Kewaunee Nuclear Power Plant
Operated by Nuclear Management Company, LLC

NRC-05-081
10 CFR 50.55a

Inservice Inspection Third 10-Year Interval June 16, 1994 - June 16, 2004 Limitation
To Examination Relief Requests of the Kewaunee Nuclear Power Plant

**INSERVICE INSPECTION THIRD 10-YEAR INTERVAL
JUNE 16, 1994 - JUNE 16, 2004 LIMITATION TO EXAMINATION RELIEF
REQUESTS OF THE KEWAUNEE NUCLEAR POWER PLANT**

ARG-W9

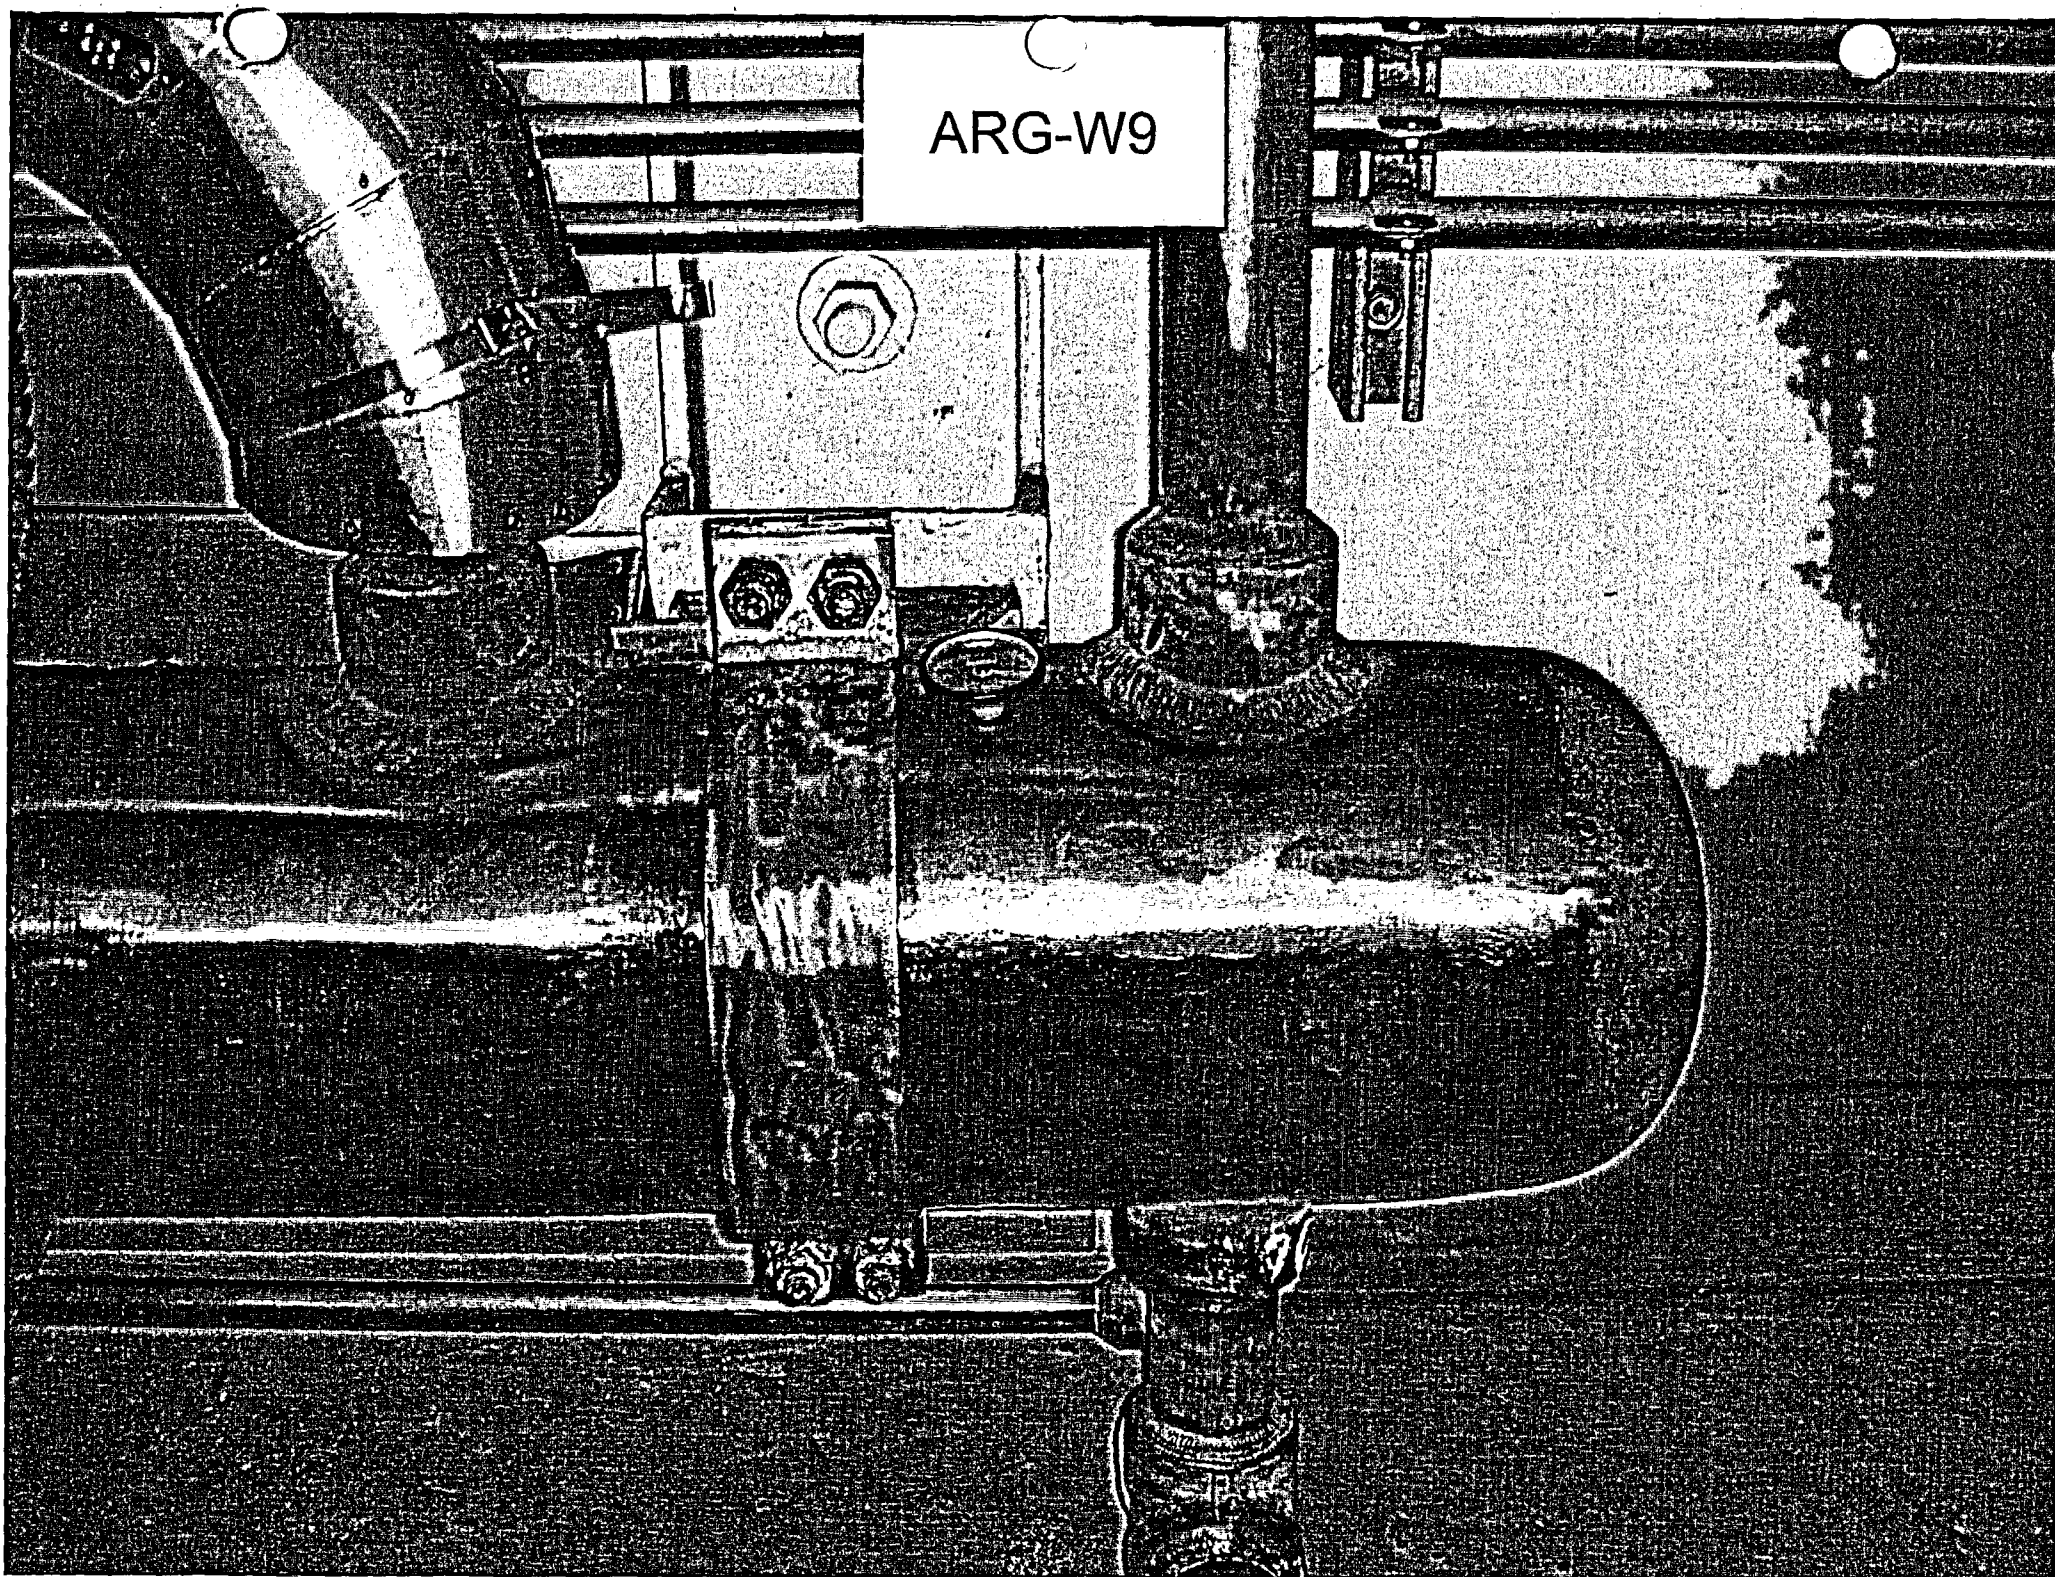
- 1. ASME Code Component Affected: Regenerative Heat Exchanger
Head Circumferential Weld ARG-W9**
- 2. Applicable Code Edition and Addenda: 1989, No Addenda**
- 3. Applicable Code Requirement: Table IWC-2500-1; Examination Category
C-A; Item No. C1.20**
- 4. Impracticality of Compliance: 1.5% of the Regenerative Heat Exchanger
Head Circumferential Weld ARG-W9 was inaccessible due to configuration
of the Regenerative Heat Exchanger 2" Nozzle thus restricting Ultrasonic
Examination.**
- 5. Burden Caused by Compliance: To provide for access to the 1.5% of the
Head Circumferential Weld ARG-W9 would require modification from
the Original Design of the Regenerative Heat Exchanger.**

**6. Proposed Alternative and Basis for Use: No alternative Code required
Ultrasonic examination is available due to the limited access. VT-2
Examinations were performed during the 3rd Interval as required by ASME
Boiler and Pressure Vessel Code Section XI 1989 Edition: Table
IWC-2500-1; Examination Category C-H; Item C7.10 each 3 1/3 Year
Period for evidence of leakage.**

LETDOWN HX
AHLD

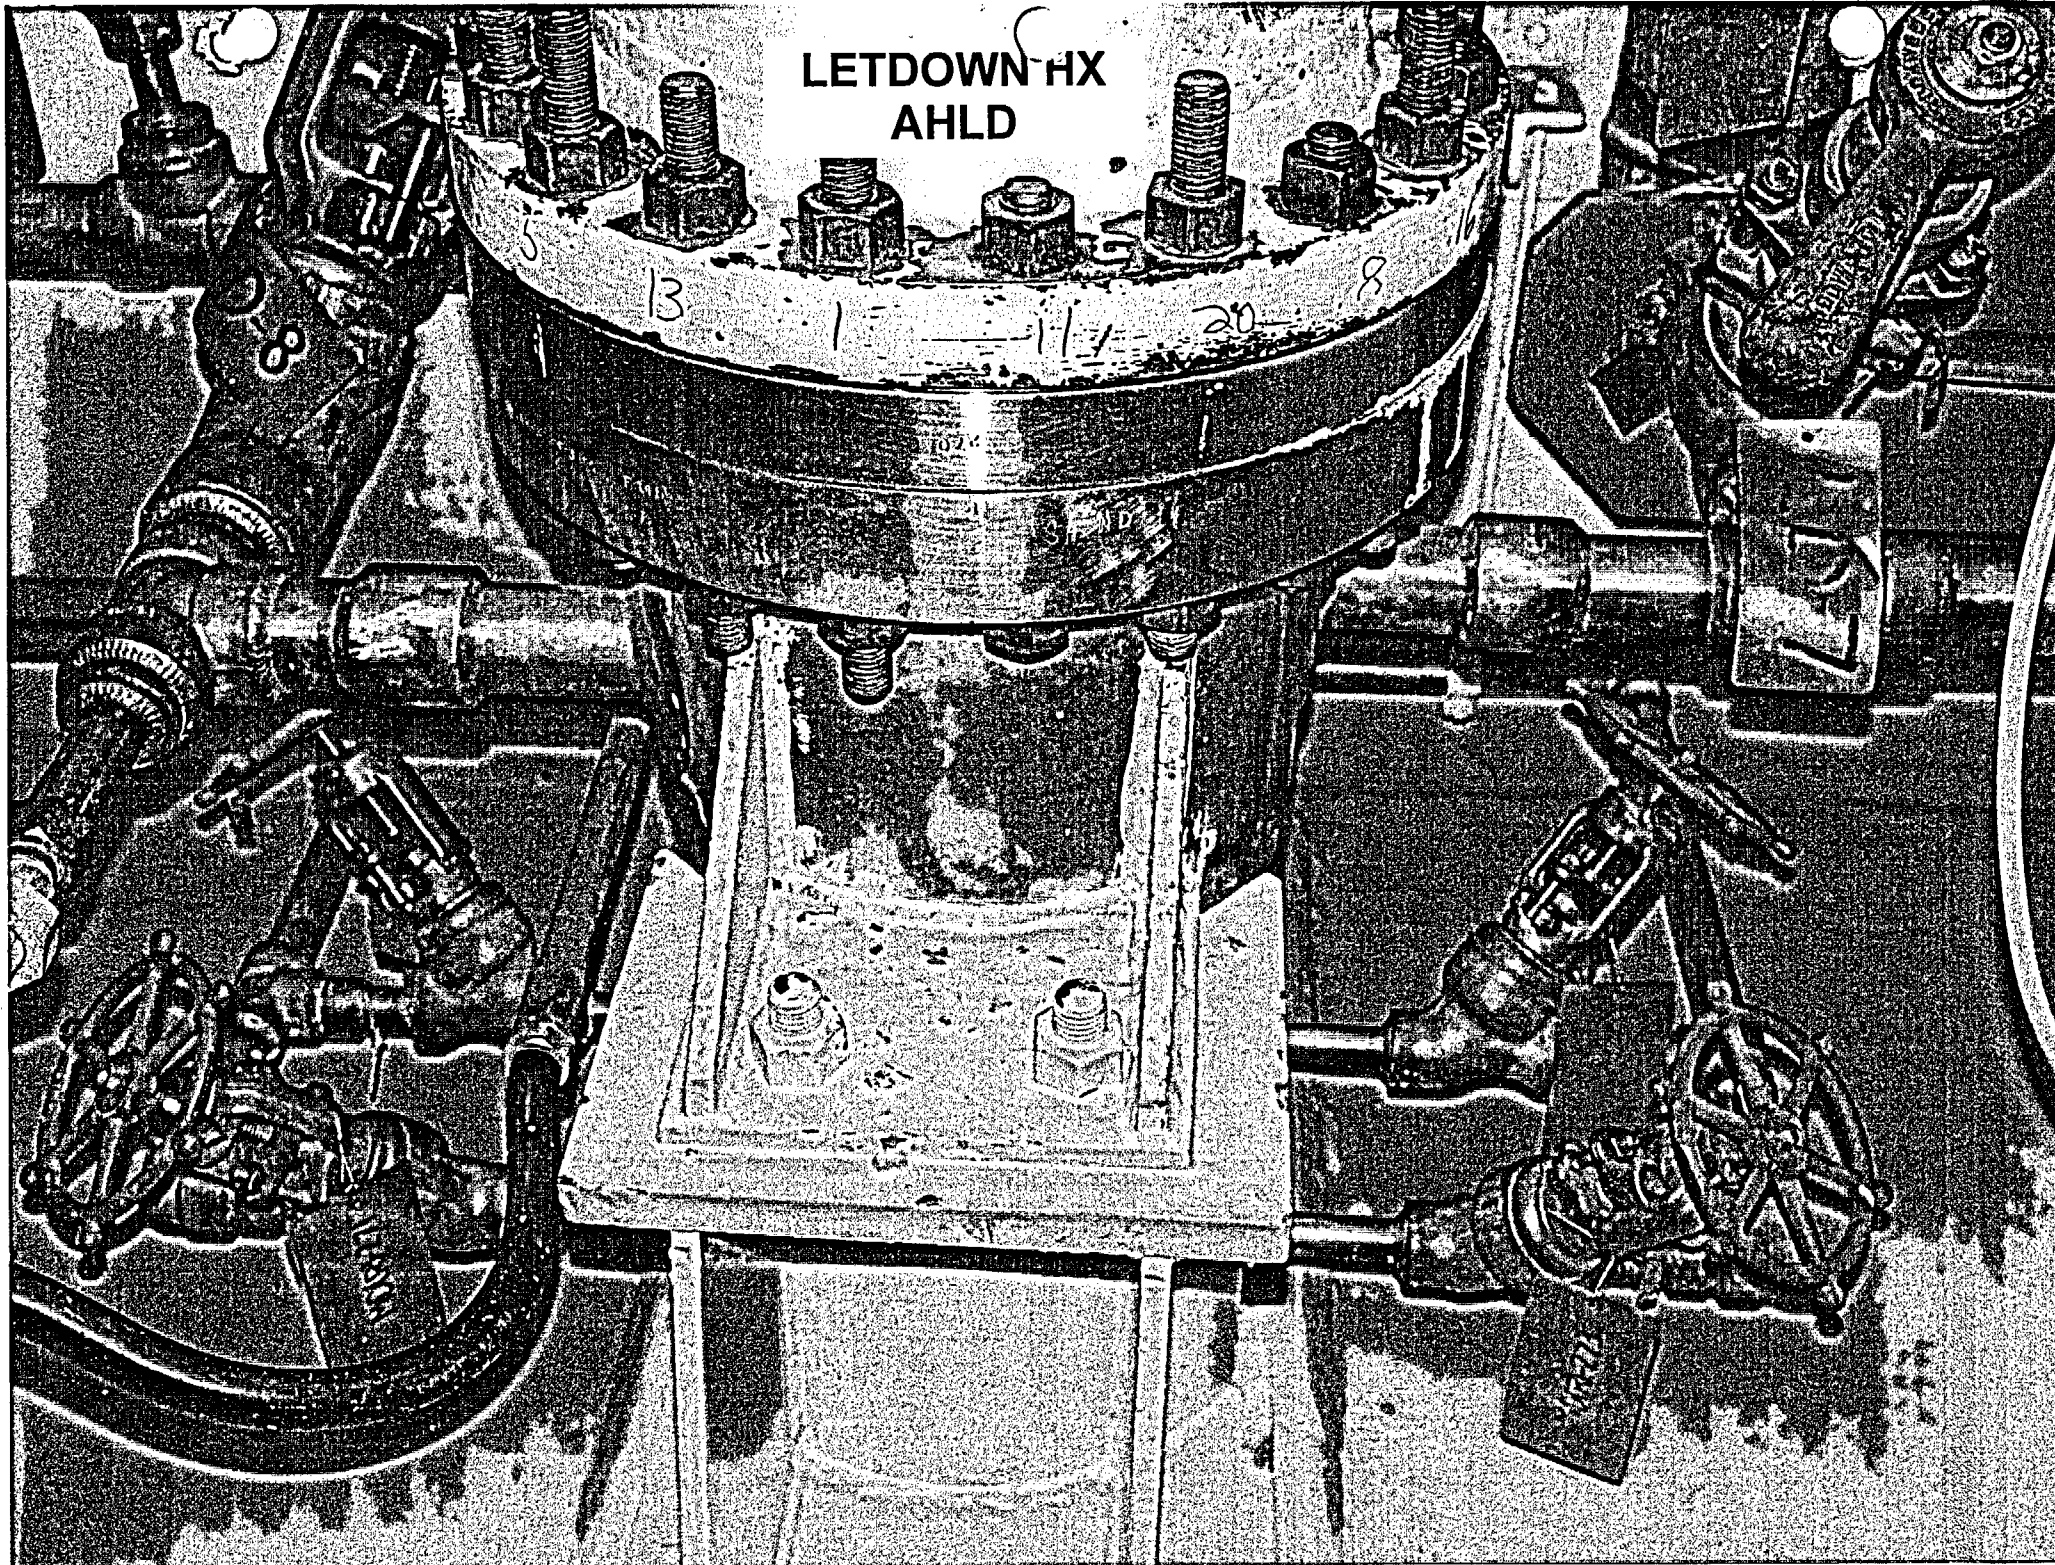
- 1. ASME Code Component Affected: Letdown Heat Exchanger
Head Circumferential Weld AHNR-W2**
- 2. Applicable Code Edition and Addenda: 1989, No Addenda**
- 3. Applicable Code Requirement: Table IWC-2500-1; Examination Category
C-A; Item No. C1.20**
- 4. Impracticality of Compliance: 43.0% of the Letdown Heat Exchanger Head
Circumferential Weld AHNR-W2 was inaccessible due to configuration of
the Letdown Heat Exchanger 2 Welded Supports and the 2" Inlet Nozzle
and the 2" Outlet Nozzle thus restricting Ultrasonic Examination.**
- 5. Burden Caused by Compliance: To provide for access to the 43.0% of the
Head Circumferential Weld AHNR-W2 would require modification from
the Original Design of the Letdown Heat Exchanger.**

6. Proposed Alternative and Basis for Use: No alternative Code required
Ultrasonic examination is available due to the limited access. However, during the Kewaunee Nuclear Power Plant 2nd Interval 1984-1994; 100% Radiography in 1988, 100% Visual From the I.D. in 1988 and 100% Liquid Penetrant From the I.D. in 1988 were performed on Seal Water Injection Filter 1A Shell Circumferential Weld AFSI-W1. VT-2 Examinations were performed during the 3rd Interval as required by ASME Boiler and Pressure Vessel Code Section XI 1989 Edition: Table IWC-2500-1; Examination Category C-H; Item C7.10 each 3 1/3 Year Period for evidence of leakage.

RC-W76DM

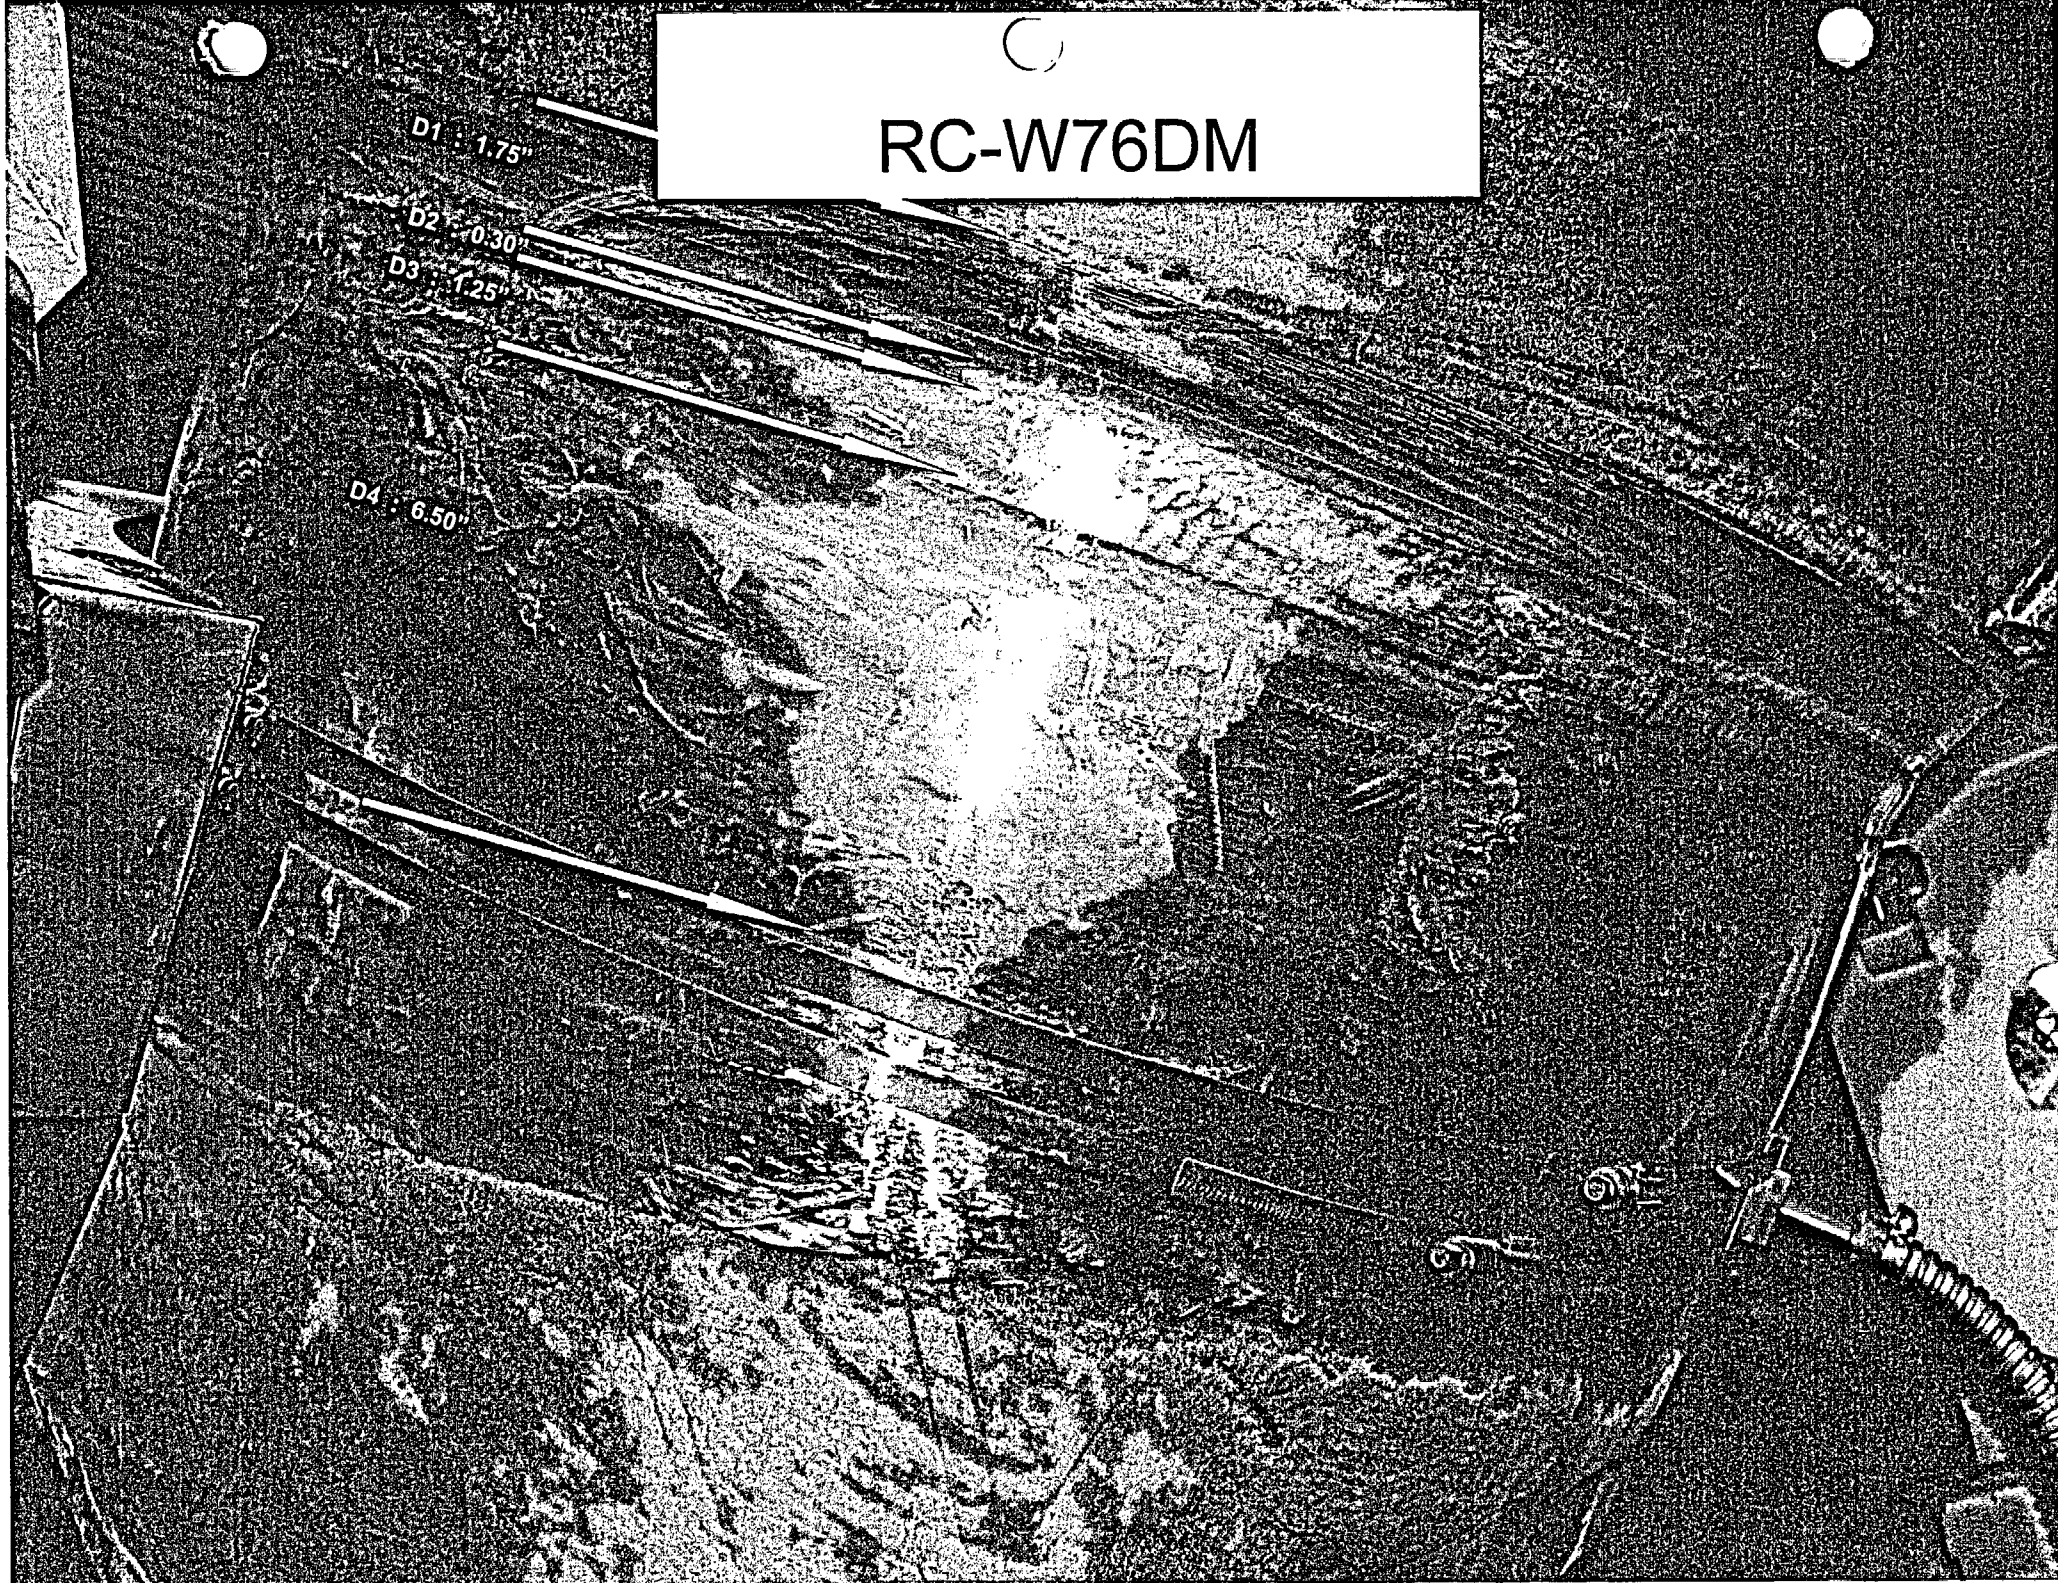
- 1. ASME Code Component Affected: Steam Generator 1A Nozzle To Safe End Butt Welds RC-W76DM and RC-77DM**
- 2. Applicable Code Edition and Addenda: 1989, No Addenda**
- 3. Applicable Code Requirement: Table IWB-2500-1; Examination Category B-F; Item No. B5.70**
- 4. Impracticality of Compliance: 38.1% of the Steam Generator 1A Nozzle To Safe End Butt Welds RC-W76DM and RC-W77DM were inaccessible due to the Nozzle Configuration thus restricting Ultrasonic Examination.**
- 5. Burden Caused by Compliance: To provide for access to the 38.1% of the Steam Generator 1A Nozzle To Safe End Butt Welds RC-W76DM and RC-W77DM would require modification of the design of Steam Generator 1A Nozzles and Reactor Coolant Pipe.**

**7. Duration of Proposed Alternative: 3rd Ten Year Interval June 16, 1994 –
June 16, 2004**
